MEMORANDUM

DATE: January 22, 2009
TO: Christopher Prucha (WM)
C.C.:
FROM: François Richard (WESA)
PROJECT #: K-B5691-6
SUBJECT: WM Richmond Landfill: Groundwater Flow in the Zone 3-10 m below Top of Bedrock

**Figure 1:
Groundwater Elevations in 3-10 m below bedrock zone
October 2008**

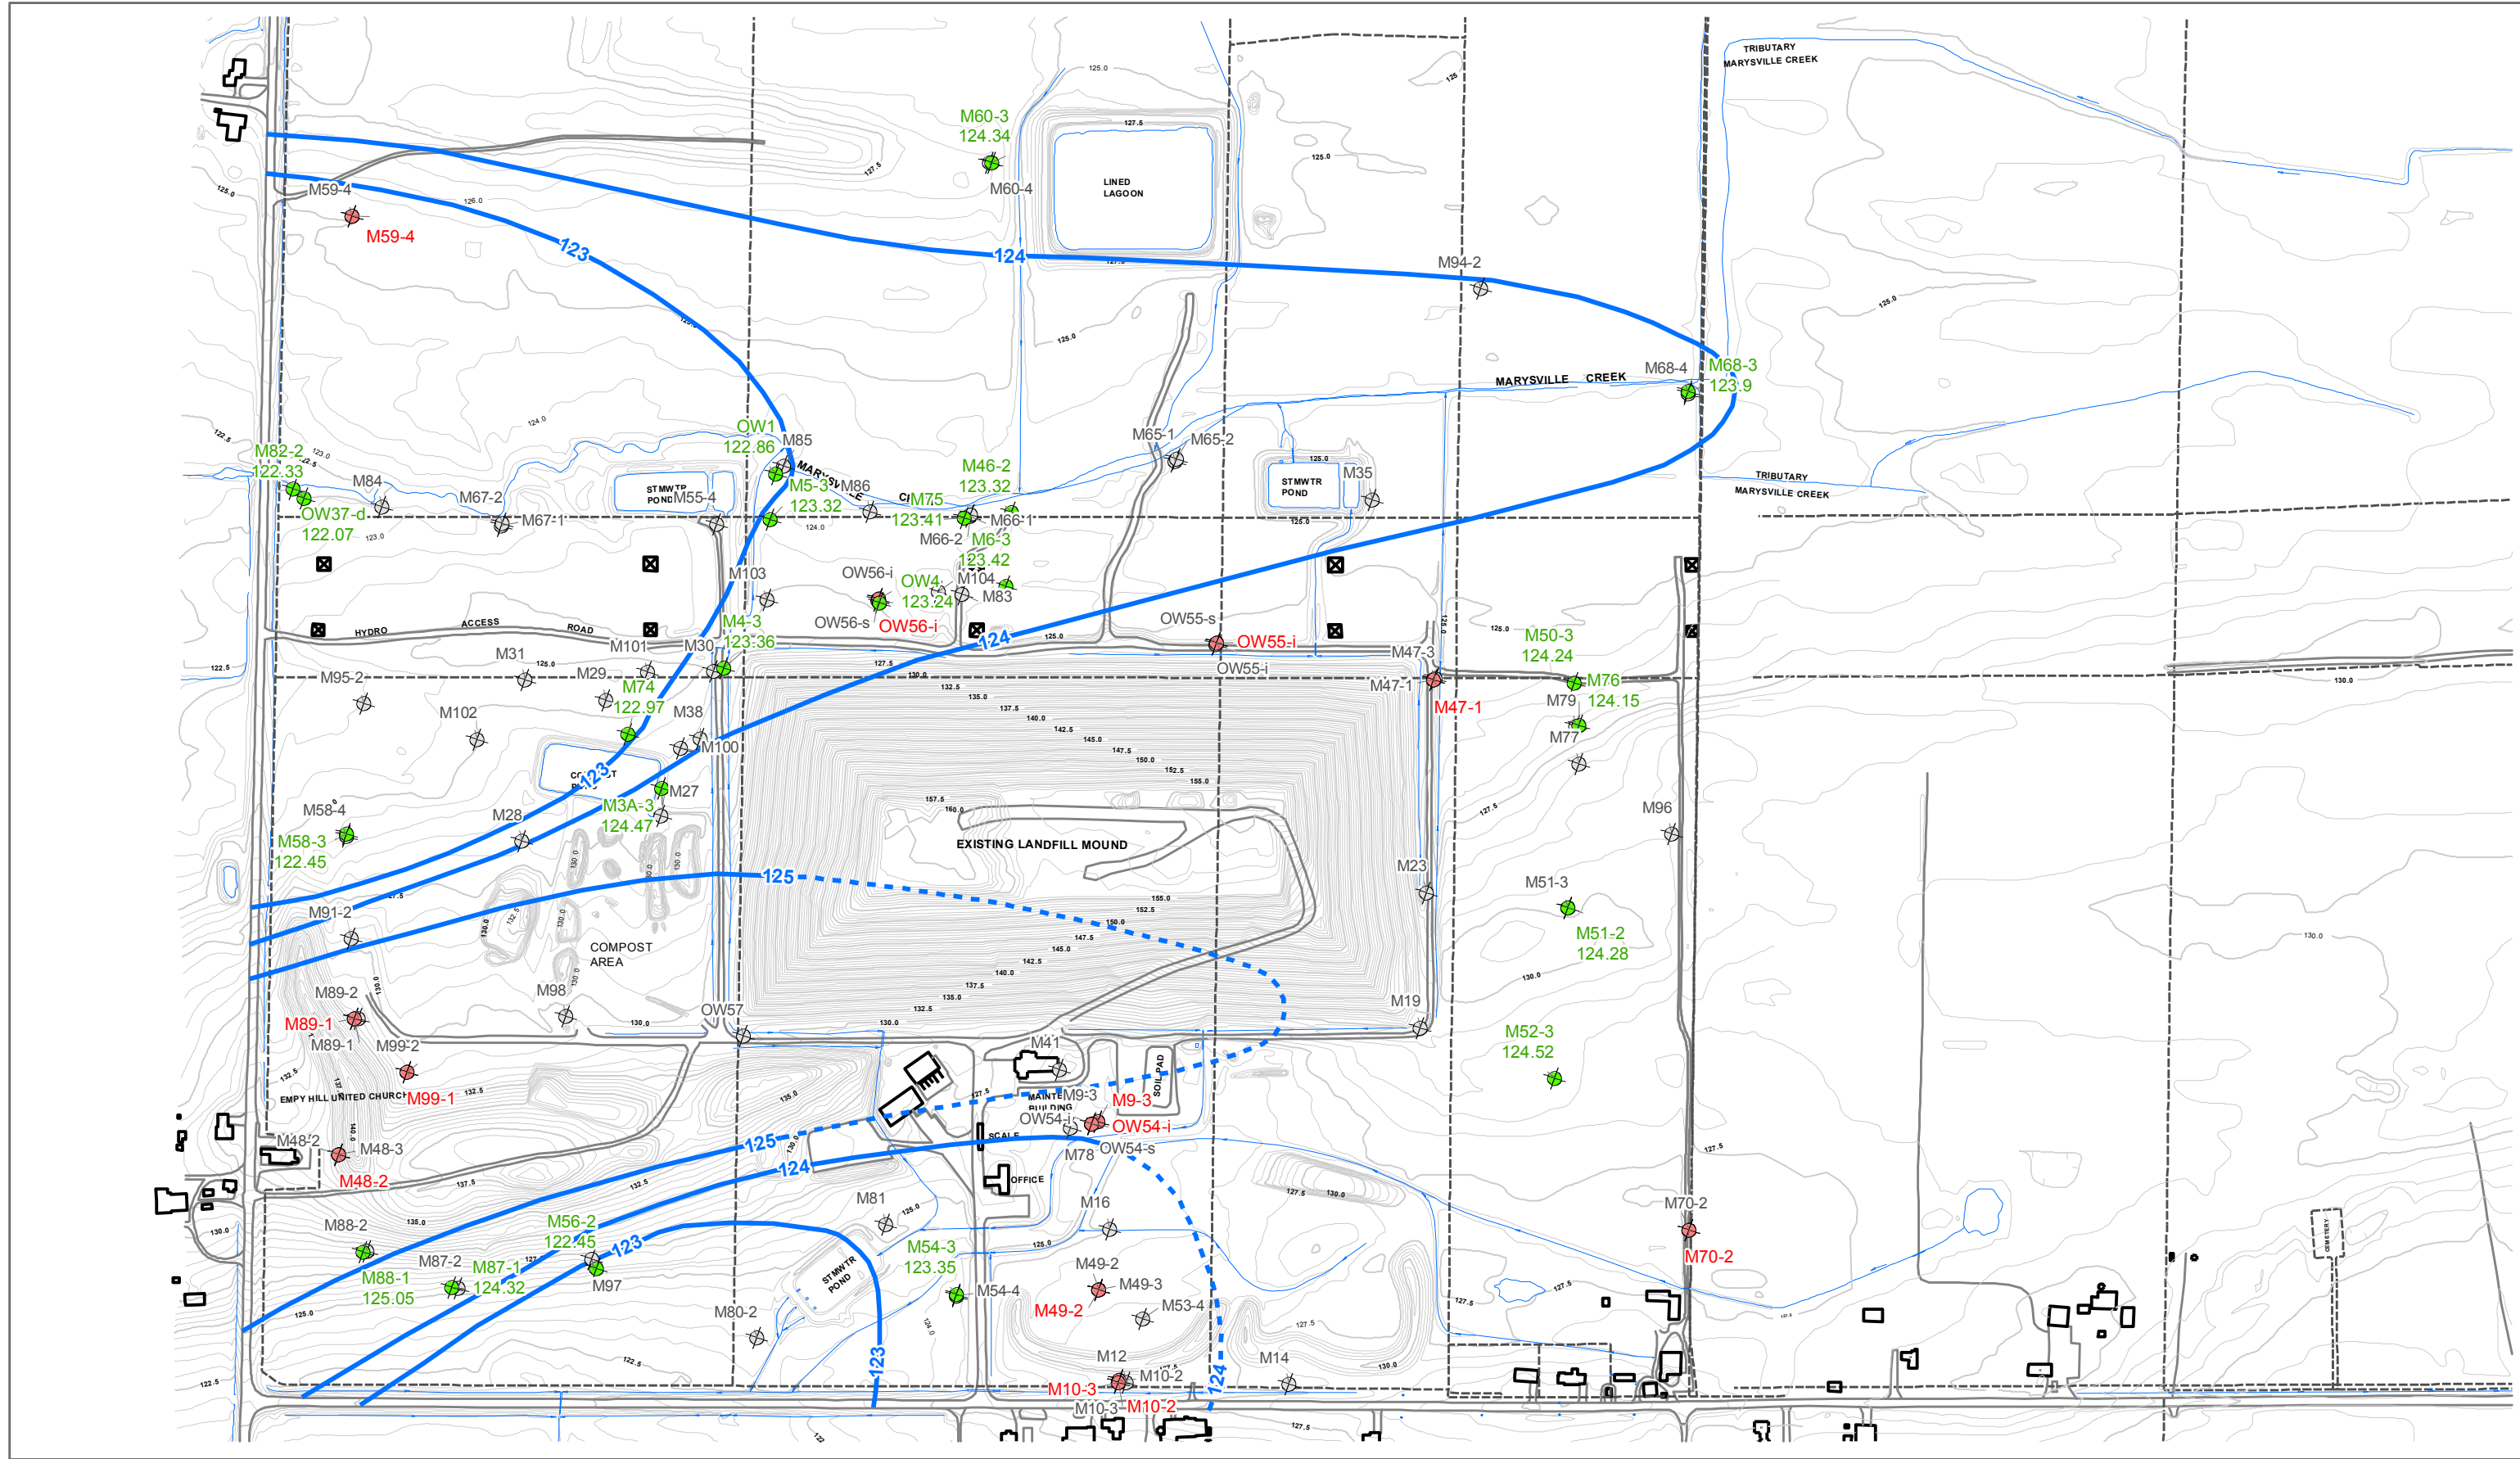
However, the MOE noted that most of the monitors retained for the contouring and interpretation of shallow groundwater flow direction are screened in overburden and/or in the upper 3 mbBR. Concerns were raised about water levels and groundwater flow directions in the portion of the bedrock immediately underlying this shallowest hydrostratigraphic unit, that is, groundwater flow in the zone 3-10 mbBR. Specifically, discussion focused on the hydraulic connectivity between this zone and the shallowest zone, and whether the groundwater flow direction is consistent between these two zones.

To address these questions, it was agreed that groundwater monitors screened between 3 and 10 mbBR would be examined and the groundwater flow interpretation reviewed. Monitors partially completed in the upper 3 mbBR were excluded in order to better assess the groundwater flow

Figure 1 identifies the monitors screened in the 3-10 mbBR zone, along with groundwater elevations measured on October 14, 2008. Monitors suitable for contouring are shown in green, while monitors not suitable for contouring are shown in red. Suitable water levels were contoured, and confirm that water levels in the 3-10 mbBR hydrostratigraphic unit are consistent with previous interpretations presented of shallow groundwater flow directions, most recently in a figure presented during the meeting (October 2008 groundwater elevations and contours), and previously in WESA (2008)¹ for groundwater elevations measured on June 27, 2008. In particular, the groundwater divide running approximately parallel to the Empey Hill drumlin has an influence on groundwater flow directions down in the 3-10 mbBR interval. Note that monitoring wells M6-3 and OW1 (both located to the north of the landfill) have historically been used in the contouring for the uppermost hydrostratigraphic unit; they are also used in the contouring of the 3-10 mbBR unit since they are screened in this zone.

Based on the information above, it can be concluded that the saturated overburden and the upper 10 mbBR behave as a single monitorable hydrostratigraphic unit. The interpreted shallow groundwater flow directions show minimal differences in the 3-10 mbBR zone compared to the shallower zone. It is therefore appropriate to use groundwater monitors screened in the overburden and/or in the upper 10 metres below the bedrock surface to characterize shallow groundwater flow at the Richmond Landfill.
